"PRELIMINARY OVERALL AREA DEVELOPMENT PLAN"

GREAT NORTHWEST, UNIT-92

THE GREAT NORTHWEST SUBDIVISION

INFORMATION SHEET FOR
P.O.A.D.P.

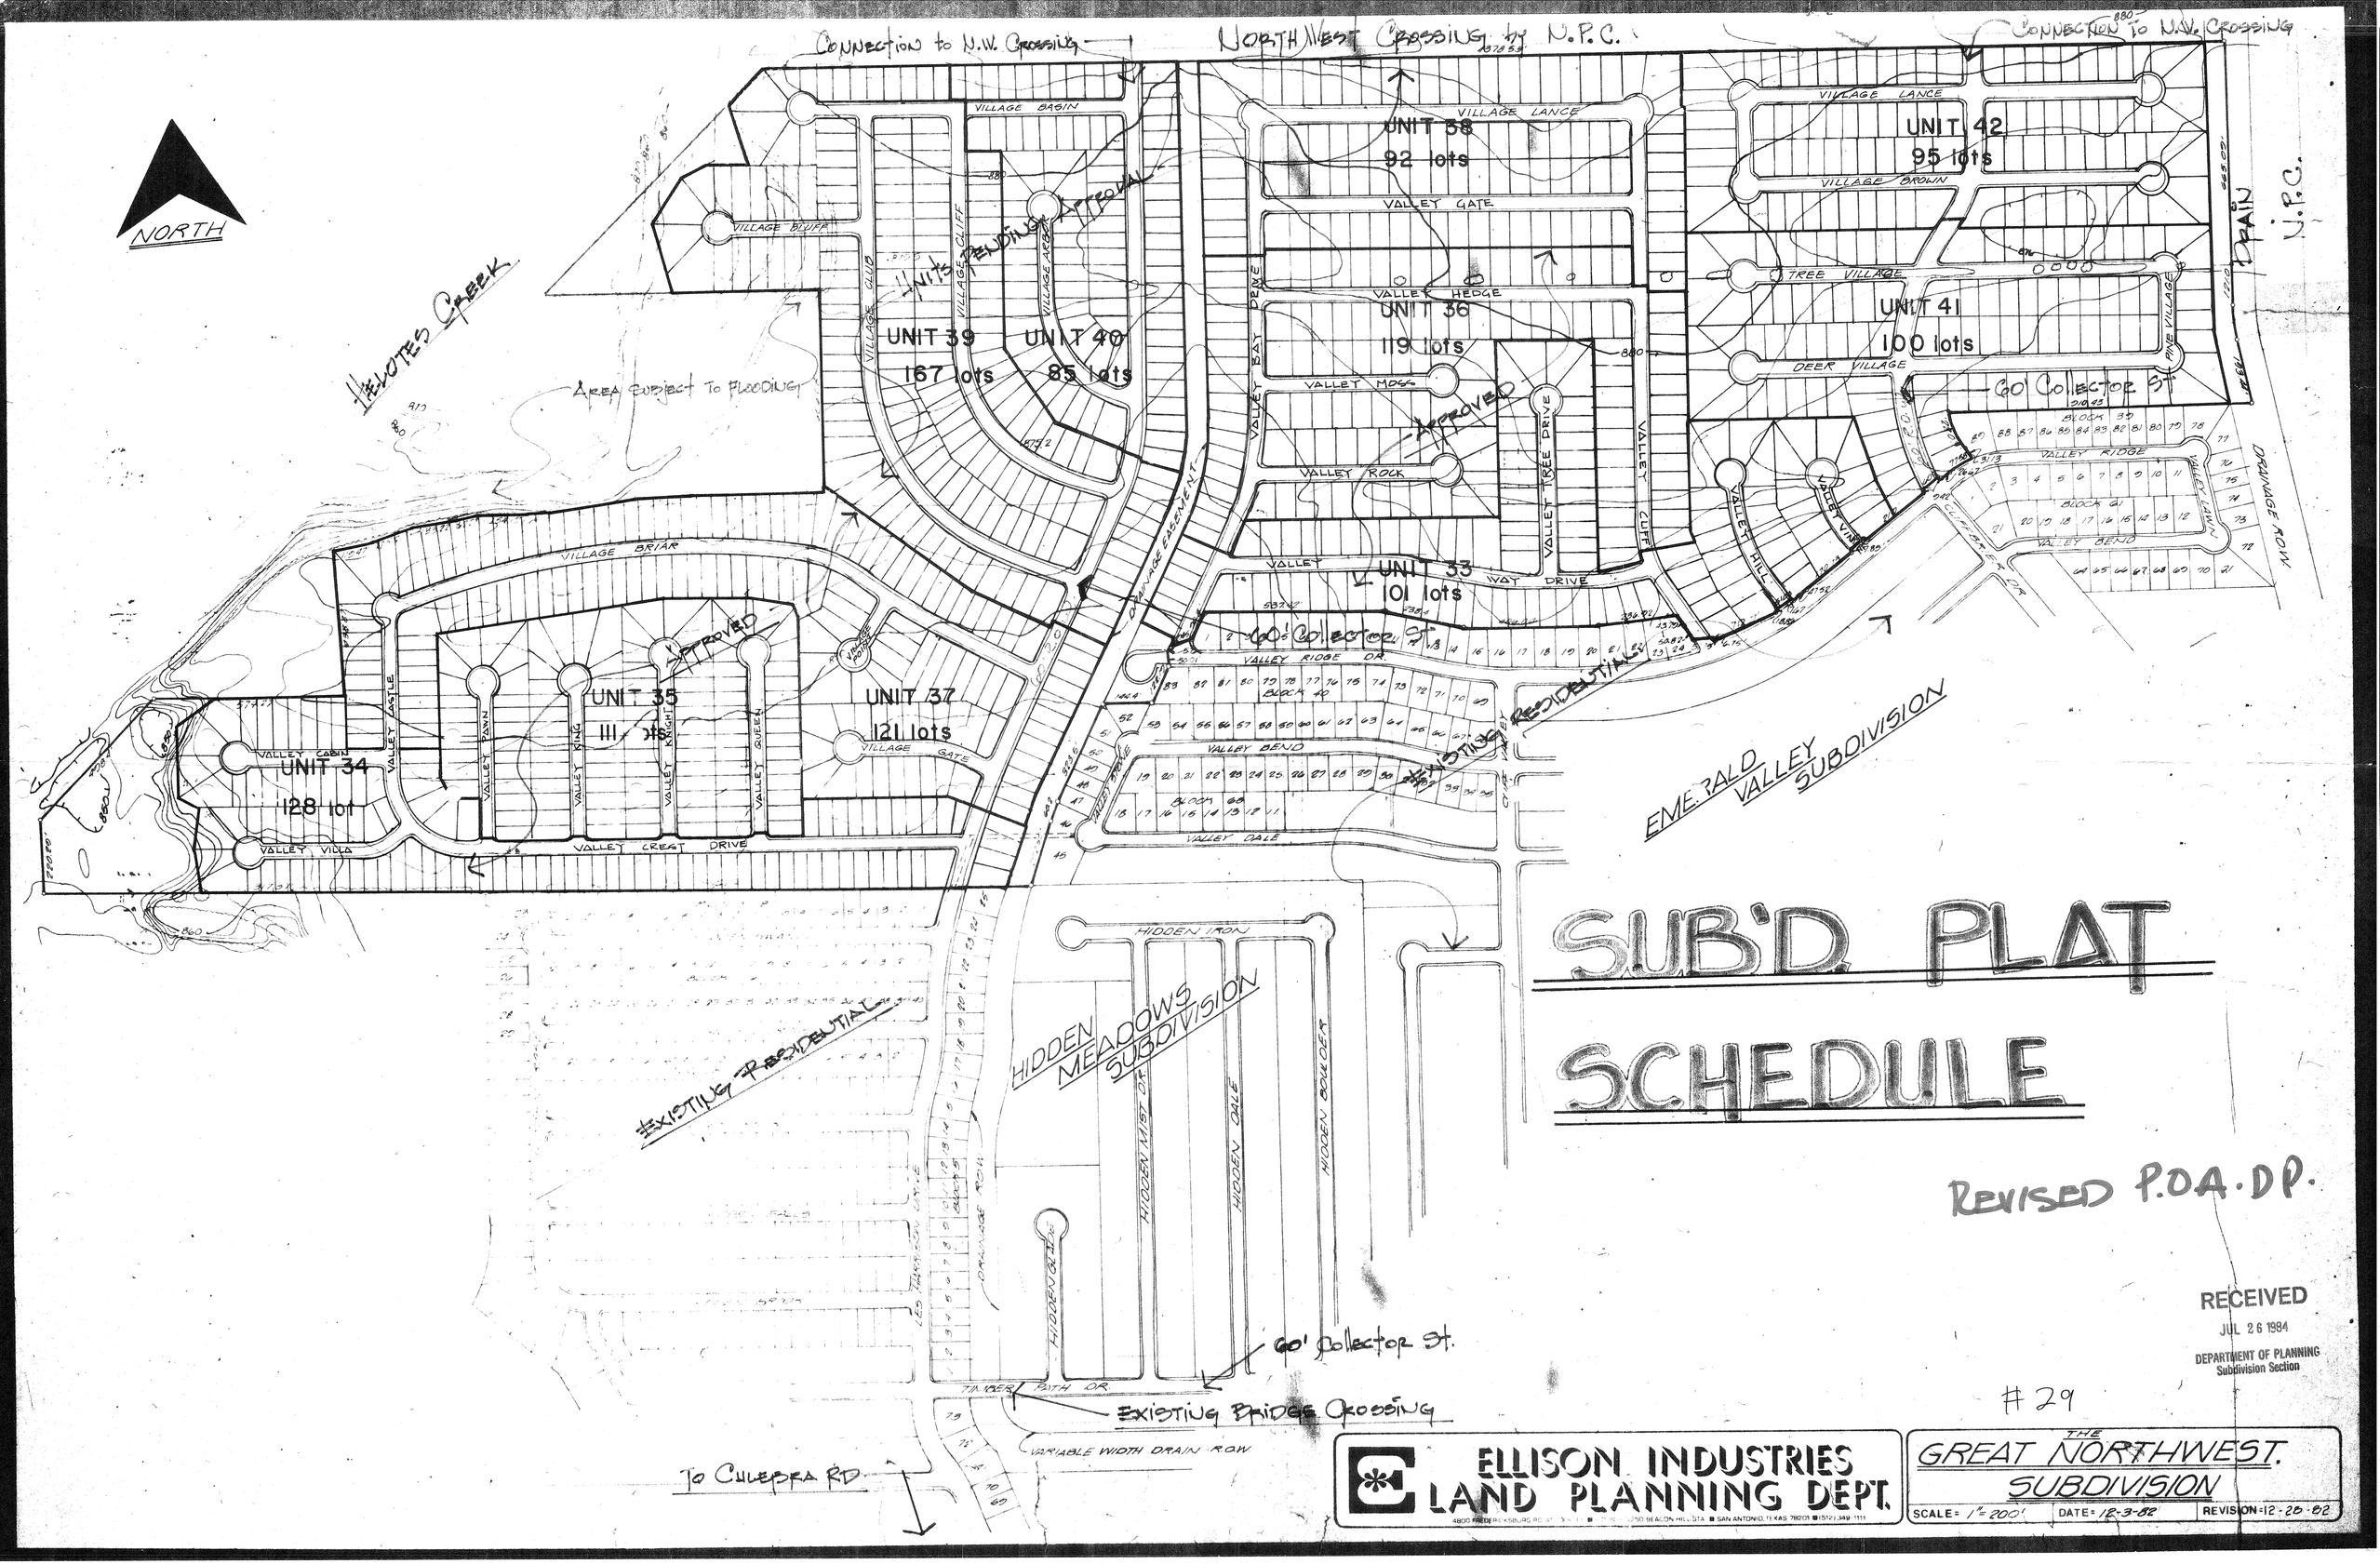
As requested in the letter of transmittal dated July 15, 1983 from your office, staff has reviewed the planned proposal for Unit 24 which was not initially taken into consideration into the Preliminary Overall Area Development Plan (POADP) review for Great Northwest File #83-16-60-62. Staff analysis of this planned concept is that it is in general compliance with Chapter 36 of the City Code.

THE GREAT NORTHWEST

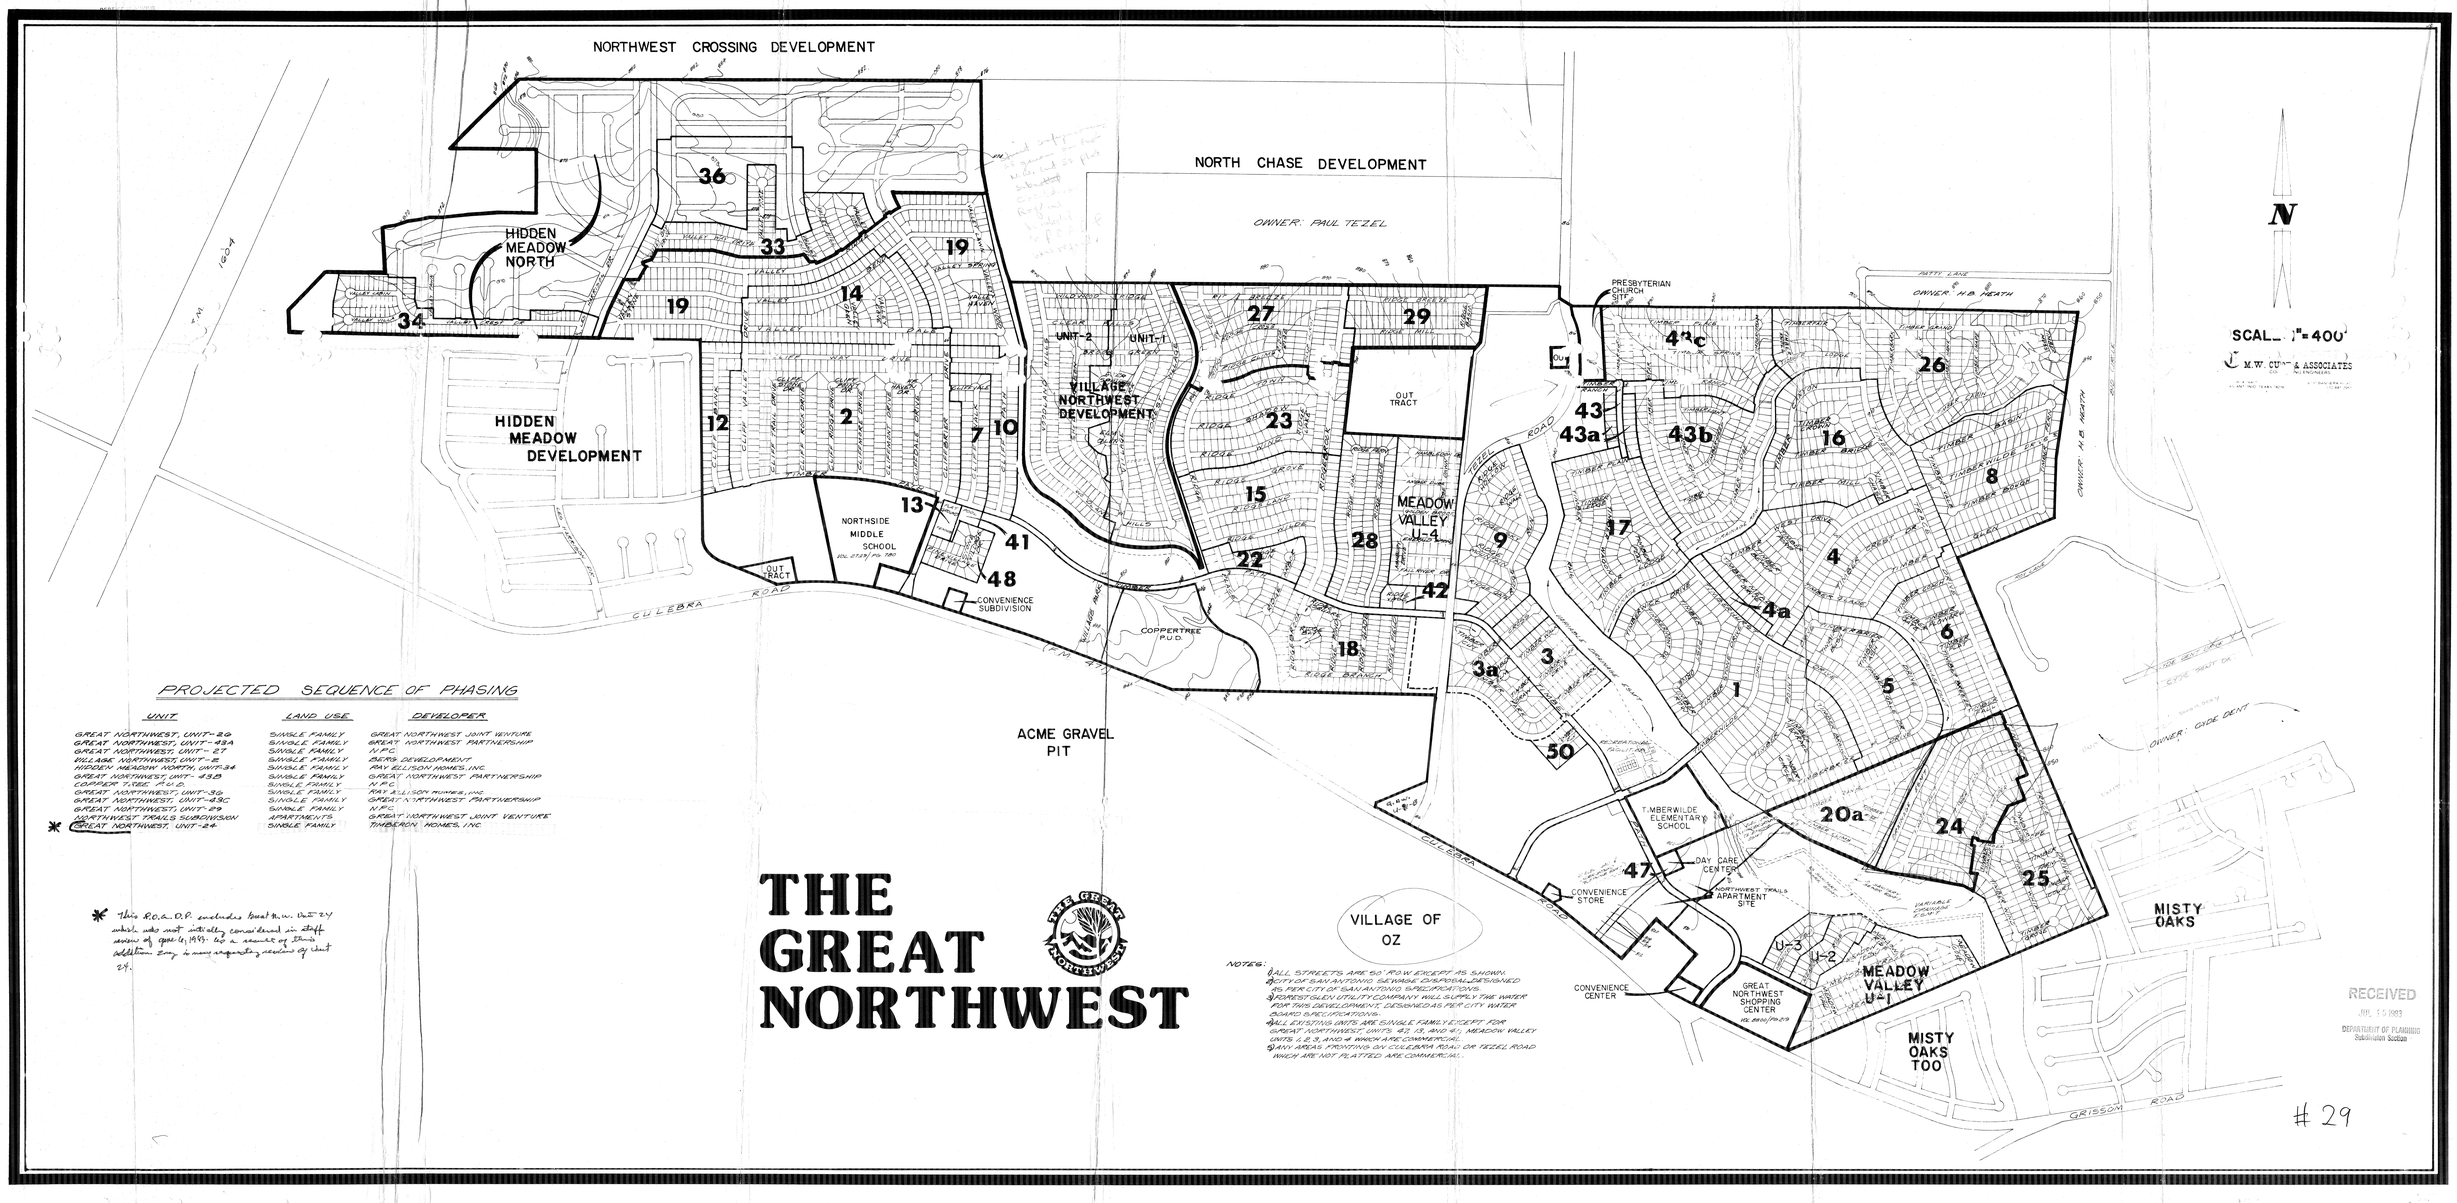
This is to inform you that the Preliminary Overall Area Development Plan (POADP) for Great Northwest (File #83-10-60-62) was jointly reviewed by Traffic Engineering and Planning staff. More specifically, said review concentrated on areas for which plats have not been approved or recorded. The areas taken into consideration were the eleven units annotated in the phasing listing on the overall plan.

Staff review concludes that the proposed scheme for the aforementioned parcels are in general compliance with Chapter 36 of the City Code with the exception of Unit-43C. The planned design does not provide for a stub street as required by Sec. 36-10(C) of the Code. In view of this, staff recommends that a stub street be provided to the northern limits of said unit. Provision for the recommended stub street will allow the future extension and a potential linkage to the north of this unit. Additionally, it is noted that Culebra Road is classified as a primary arterial type "A" street ([illegible]' R.O.W.) on the Major Thoroughfare Plan. Any platting occurring along this stretch of thoroughfare will require dedication for future street widening in accordance with the Major Thoroughfare Plan.
